TECH NOTES

TECH NOTE # TN 97-5

Vibro-King

SYMPTOMS:

fig. 1

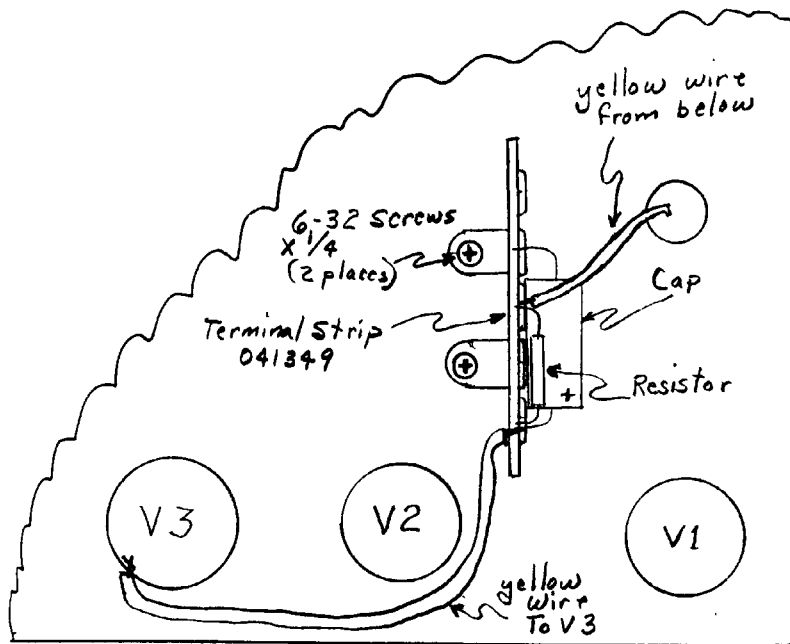
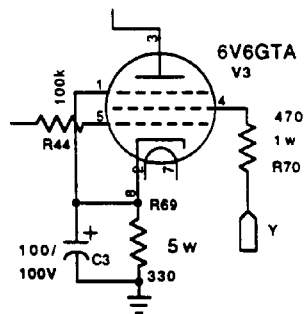
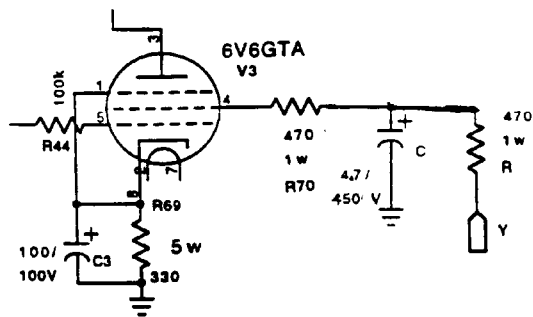
Unit has excessive hum in reverb.

The screen grid of the 6V6 reverb driver tube is being modulated by 120 Hz ripple from the power supply. This can be reduced by adding decoupling components, R & C

- 1) Drill 2 holes to accomodate 6-32 screws, 3/4" spacing, in the approximate position shown in fig. 1; mount the terminal strip as shown.
- 2) Cut the yellow wire that runs through the hole in the chassis to V3, at a point that will allow the ends to be connected to the terminal strip as shown.
- 3) Attach positive end of C401, one end of R401, and the yellow wire attached to V3 to the end terminal.

- 4) Attach the negative end of C401 to the terminal that connects to chassis.
- 5) Attach the other end of R401 and the yellow wire to an unused terminal.

Change from

Change to
